## Re: Port Colorado – Sub-Area 2 – Master Plan (DA-1793-05) Submittal #5 – Response to Submission Review #4

Port Colorado  
Sub-Area 2  
Planning Area Plan  
Tab #8

# Public Improvement Plan

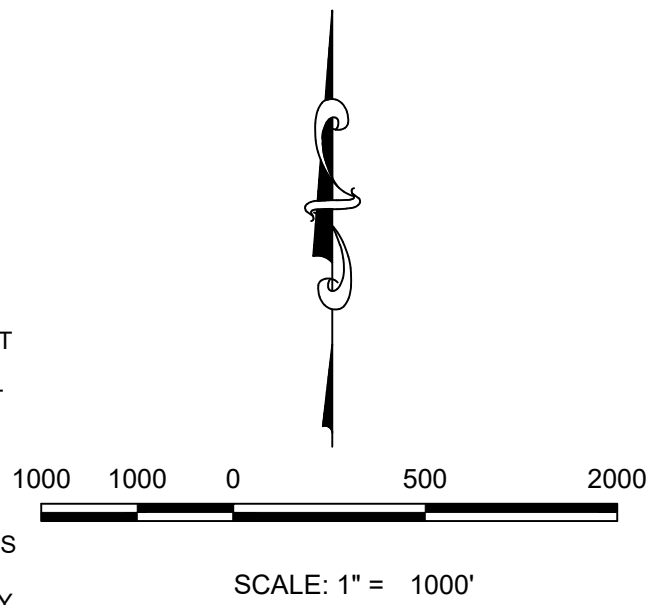
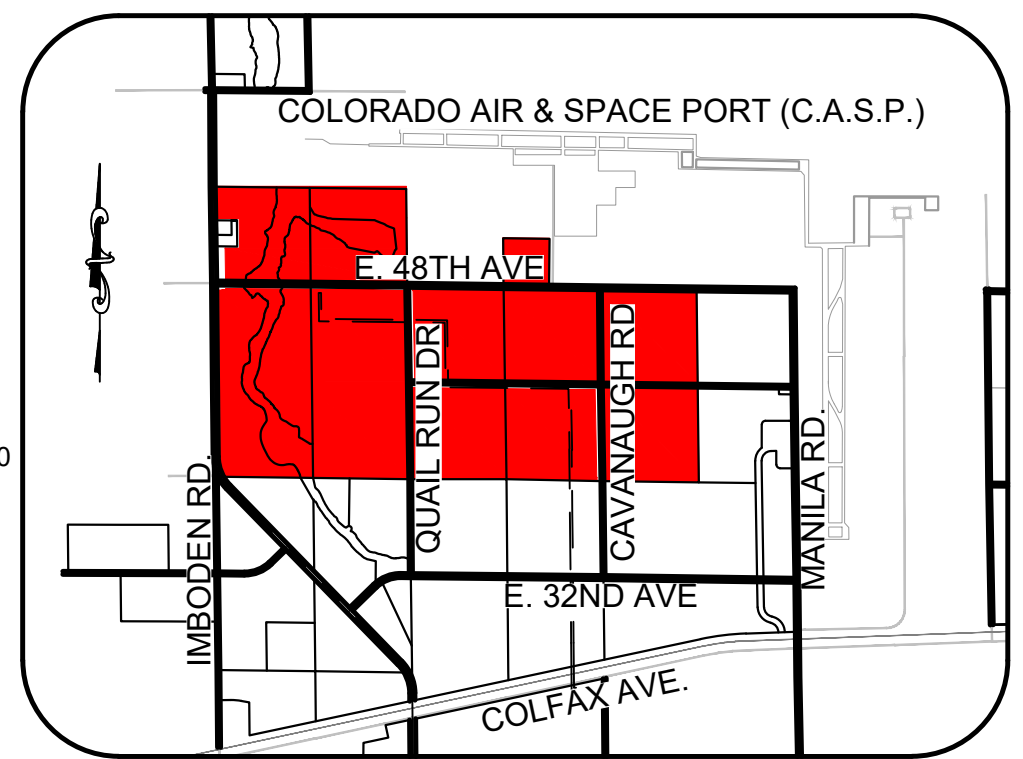
verify intersection control with TIS

Intersection control has been updated to match TIO long-term control.
